**E5515C-14A**

# **S E R V I C E N O T E**

## **E5515C Wireless Communications Test Set (8960 Series)**

**DSP code will not load when the instrument is booting up.**

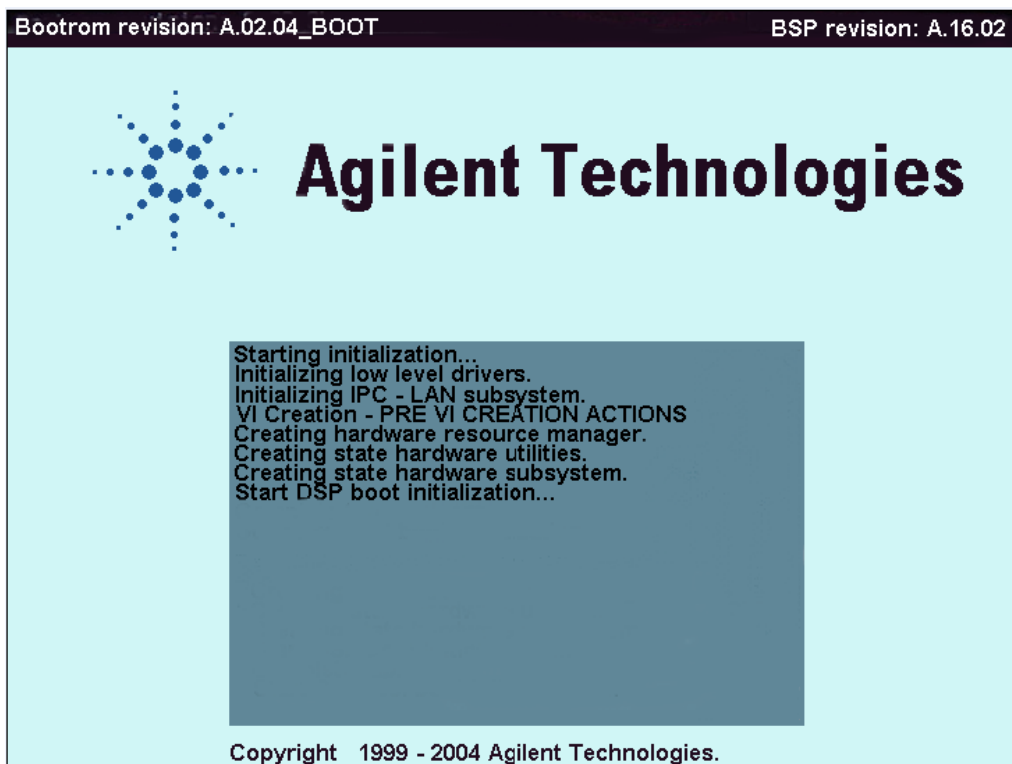
When the E5515C is booting up it will stop at the below screen, which indicates that the Digital Signal Processor assembly has stopped working.

**Note:** The information in the top black box can be different based on Firmware revision installed.

1. Verify that the E5515C instrument serial numbers is between **MY48360100 / MY48361000**
2. Remove the external covers and then the internal top cover to gain access to the DSP board. The DSP assembly is the seventh pc board assembly from the rear of the instrument.

**NOTE:** Change the whole DSP assembly with **E5515-61845** or **E5515-69845** if available
